**A12 Chelmsford to
A120 widening scheme**

TR010060

**DEVELOPMENT CONSENT ORDER
CHANGE APPLICATION:
TRANSPORT ASSESSMENT ADDENDUM**

**Development Consent Order Change Application:
Transport Assessment Addendum**

Plate 2-2 Updated design of Junction 19 northbound on-slip road

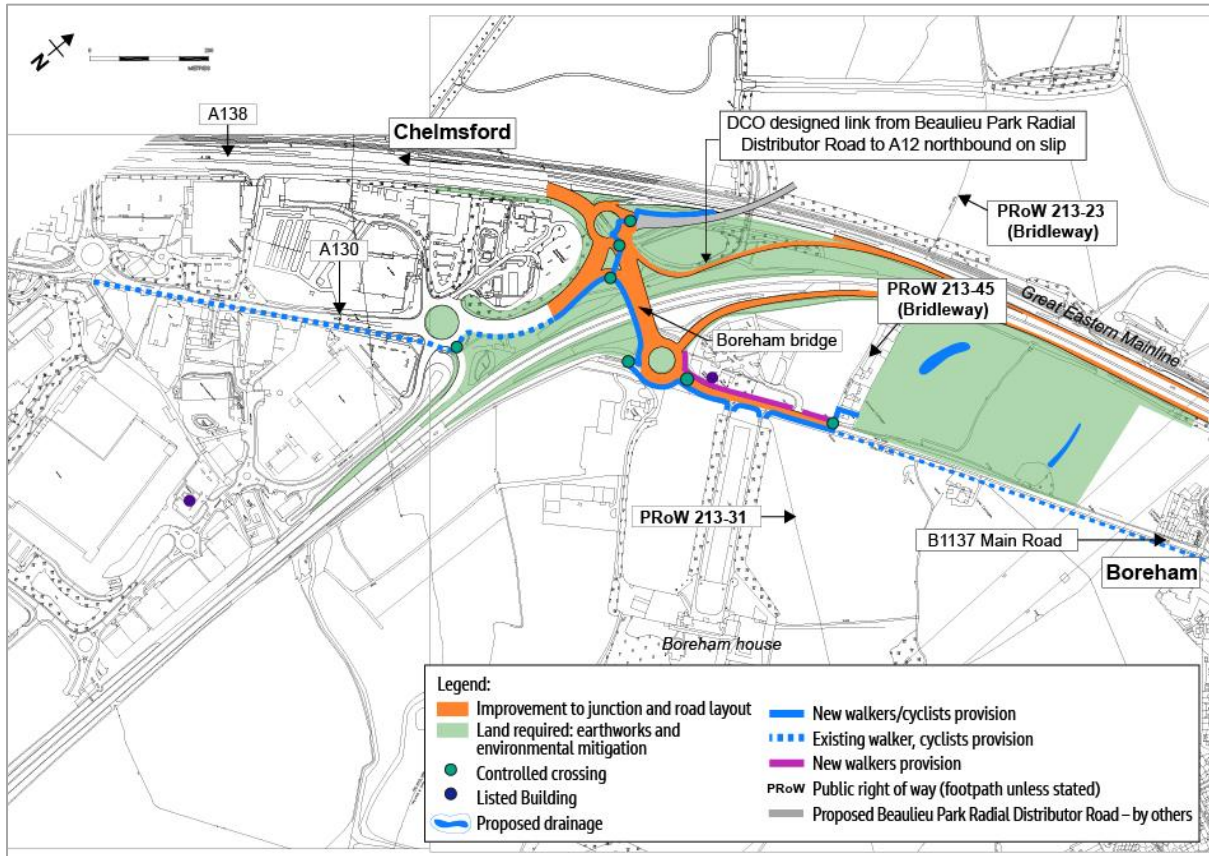
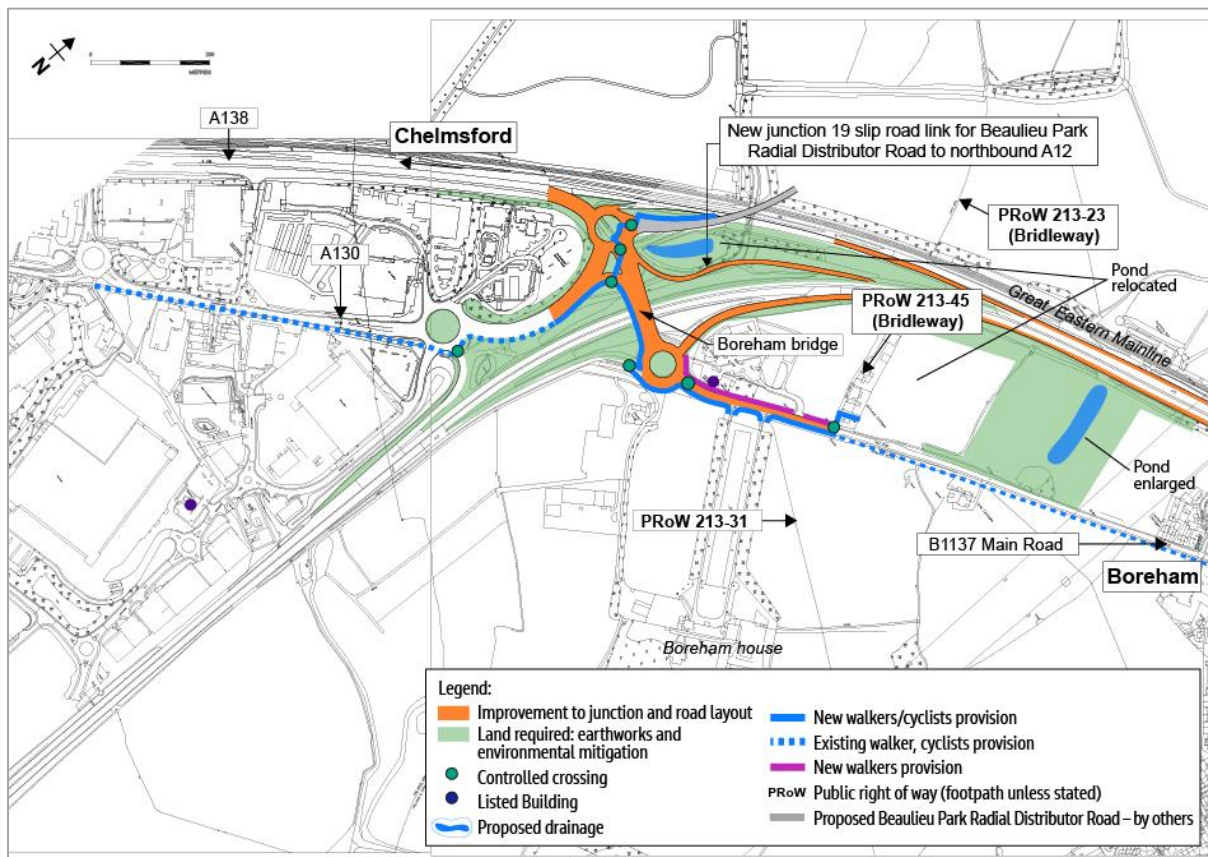
2.2.1 In the design submitted with the DCO application, traffic travelling between the Beaulieu Park Radial Distributor Road and the northbound A12 would use a segregated left turn lane, which connected to the existing junction 19 northbound on-slip road. This merge was proposed to use an offside merge, which would require traffic to join the offside lane 2 of the junction 19 northbound on-slip road. The proposals submitted under the DCO application can be seen on Plate 2-1.

2.2.2 It is proposed that this arrangement would be improved by connecting the link from the Beaulieu Park Radial Distributor Road directly to the A12 northbound carriageway. This proposed merge would be more conventional, in that the merging slip road would join the nearside lane 1 of the A12. The updated design can be seen on Plate 2-2 and sheet 2 of the updated General Arrangement Plans in Map Book 1 [TR010060/EXAM/10.5].

- 2.2.3 As described above, the proposed change would mean that traffic from the Beaulieu Park Radial Distributor Road wanting to join the A12 northbound at junction 19 would join the A12 directly via a new slip road, rather than joining via the existing northbound slip road. This would mean a slightly different journey for that traffic, and the traffic on those slip roads would change as a result.

- 2.2.4 However, traffic modelling work predicts that this change would not result in other unaffected drivers changing which routes they take for their journeys. Only the two slip roads and the short section of A12 between the slip roads would see a change in traffic numbers. There would be almost no change in traffic on any other roads. The traffic model does predict very slight changes in traffic on some roads, but these are so extremely small that they have been dismissed as ‘model noise’ and not taken forward for detailed assessments of environmental impacts or capacity calculations.

- 2.2.5 As there are no significant changes in traffic using the roundabouts within junction 19, there would be no effect on the operational performance of the junction as reported in the Transport Assessment.

Plate 2-3 B1023 roundabout design submitted with DCO application

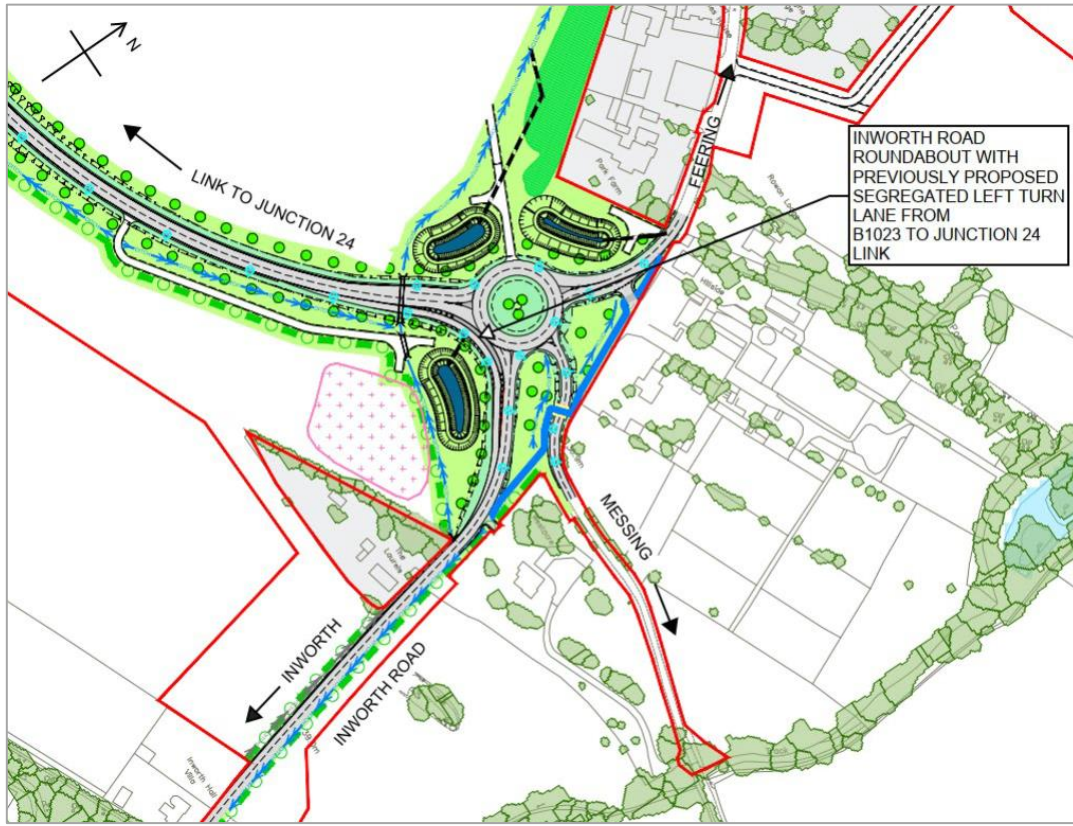
- 2.3.1 In the designs submitted with the DCO application, a segregated left turn lane (SLTL) was proposed for traffic from Inworth Village at the B1023 roundabout. A SLTL is used to provide a link for traffic turning left at roundabouts which bypasses the roundabout itself. This feature allowed traffic from Inworth Village to join the link road to junction 24 without the need to give way to traffic already on the roundabout, reducing the delay for vehicles from this approach. The proposals submitted under the DCO application can be seen on Plate 2-3.

- 2.3.2 The Applicant is proposing the removal of the SLTL from the arrangement of the B1023 roundabout that was presented in the DCO application. Traffic from Inworth Village would instead join the link road to junction 24 by using the B1023 roundabout. This would require traffic on the B1023 to give way to traffic already on the roundabout, as is the case with most roundabouts. The updated design can be seen on Plate 2-4 and sheet 14 of the updated General Arrangement Plans in Map Book 5 [TR010060/EXAM/10.9].

- 2.3.3 Although traffic joining junction 24 on the approach from Inworth Village would have to use the Inworth Road roundabout itself to access junction 24 rather than a separate left-hand turn lane, this is not predicted to significantly affect the performance of the junction. All arms of the roundabout are still predicted to operate with a Level of Service 'A' (i.e. the best level of operation), the same as was reported in Table 4.1 of the Transport Assessment submitted as part of the DCO application [APP-253]. More detail on the impact on the operational performance of the roundabout in terms of queue lengths and delays is presented in Chapter 3 of this report.
- 2.3.4 The proposed change is not predicted to result in drivers changing their routes to and from the A12, so there would be no change in the amount of traffic on any roads.

Plate 2-6 Updated junction 25 design

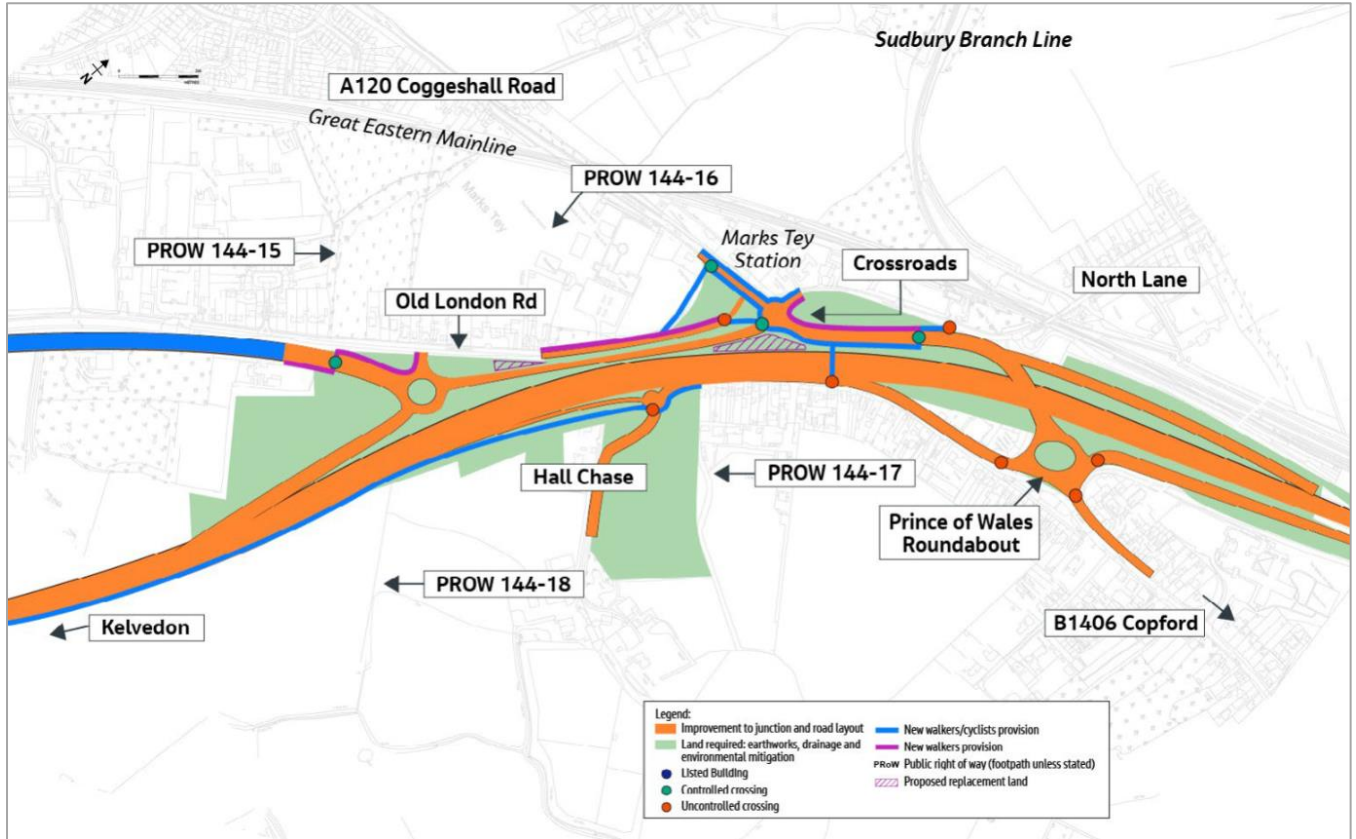
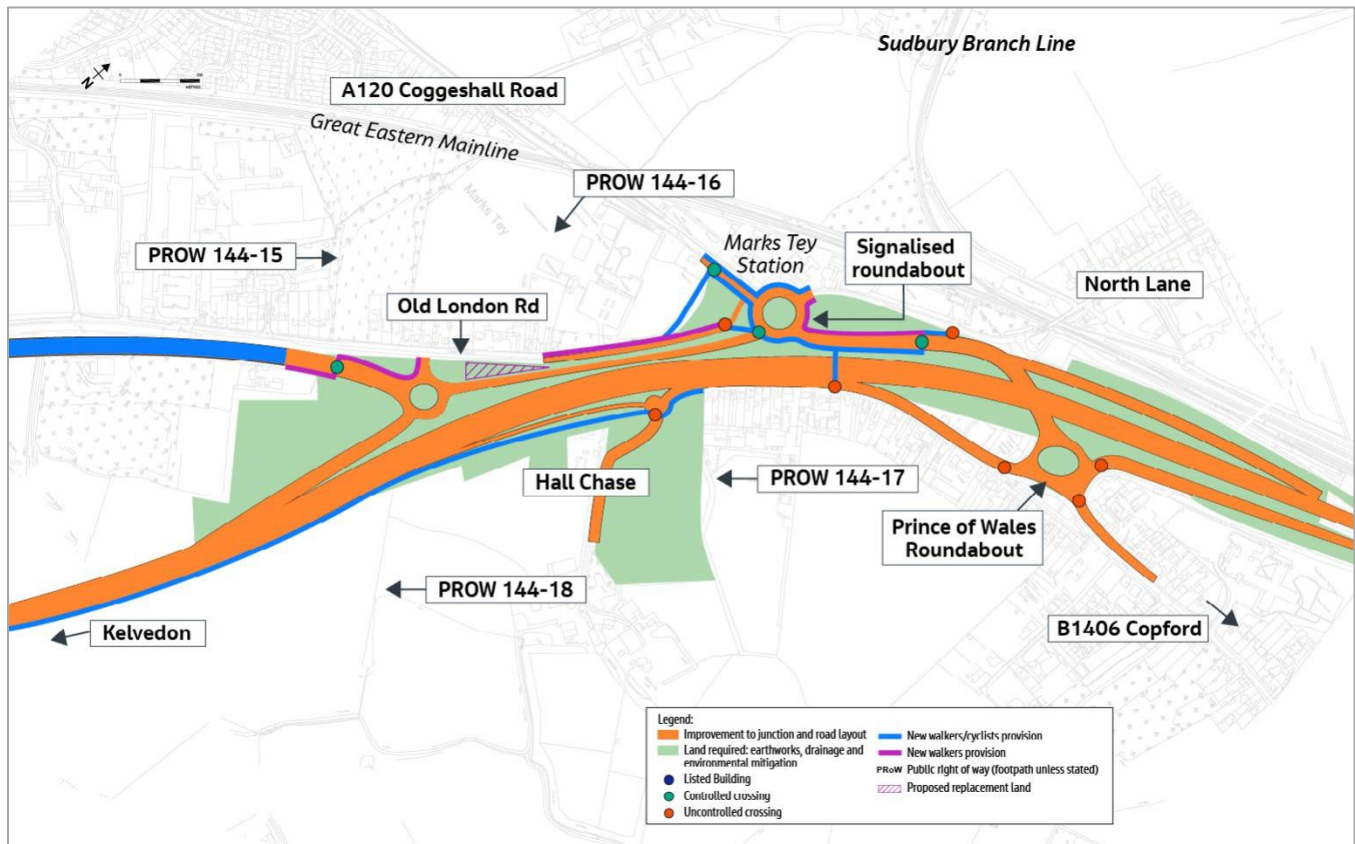
- 2.4.1 In the designs submitted with the DCO application, junction 25 was to remain an elevated junction and provide access to the A12 both northbound and southbound. These proposals converted the Old Rectory Junction roundabout to a signalised crossroads. The proposals submitted under the DCO application can be seen on Plate 2-5.

- 2.4.2 The Applicant is proposing to change the configuration of junction 25 to remove the signalised crossroads proposed in the design submitted with the DCO application and implement a partially signalised roundabout design to maximise the use of existing infrastructure and minimise loss of existing trees within the Old Rectory Junction roundabout island. The retention of the roundabout, albeit with its signalisation, requires less land acquisition and has smaller impacts on the proposals for replacement land in this location. There would also be consequential changes to the utility diversions in this area. The updated design can be seen on Plate 2-6 and

sheets 18 and 19 of the updated General Arrangement Plans in Map Book 6 Part 1 of 2 [TR010060/EXAM/10.10].

- 2.4.3 The impact that the proposed change in design would have on the operational performance of junction 25 in terms of queues and delays is presented in Chapter 4 of this report.

- 2.4.4 In terms of traffic flows, the proposed change is predicted to result in some changes in traffic flows on the A12 itself and on local roads. This is because of slight changes in how long it takes to travel through the junction from different approach arms.

Plate 2-7 Change in traffic around Junction 25 due to proposed change

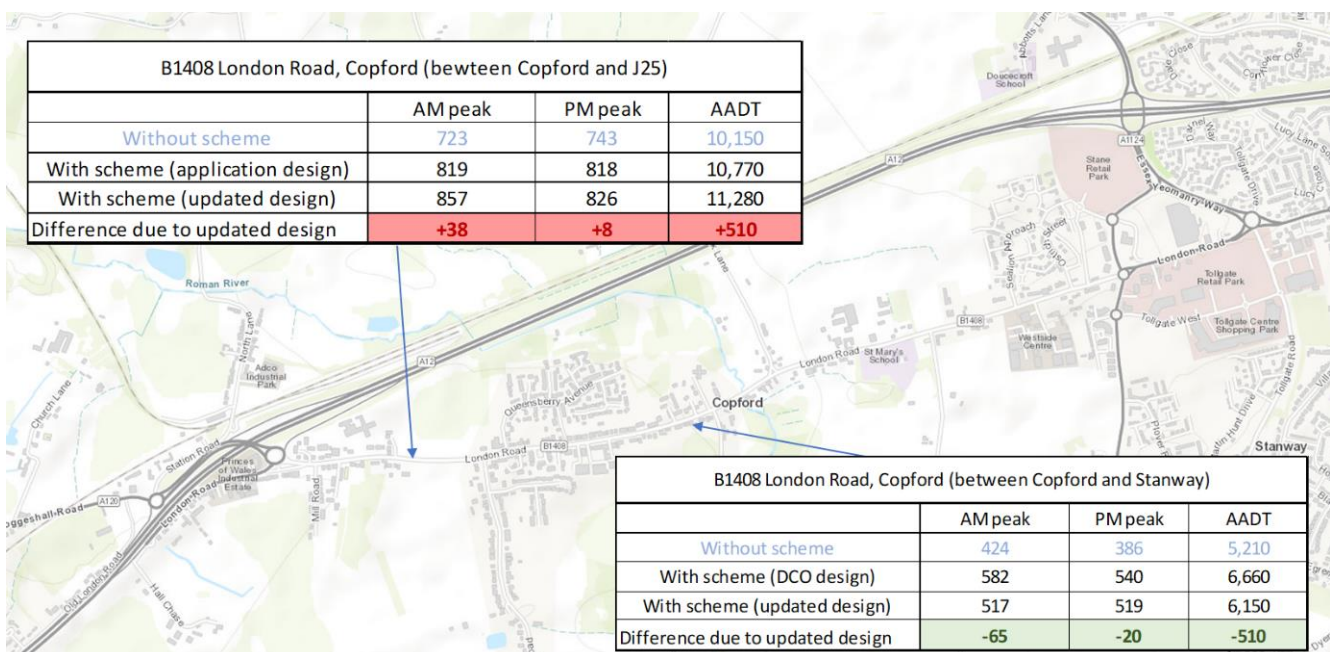
- 2.4.5 The main predicted change in traffic flows is that more traffic from Copford would use junction 25 (Marks Tey) to access the A12 northbound, instead of travelling via B1408 London Road and joining the A12 at junction 26 (Stanway). This is because it is easier to make this movement if the Old Rectory Junction was a partially-signalised roundabout than if it was a signalised crossroads. Compared to the design presented in the DCO application, this change would therefore cause a slight increase in traffic travelling around both the Prince of Wales roundabout and the Old Rectory Junction, and a slight decrease in traffic on the B1048 London Road between Copford and Stanway.

- 2.4.6 The change in traffic flow on these roads is shown in Plate 27 below. This shows the predicted change in 2027 traffic flows as a result of the new
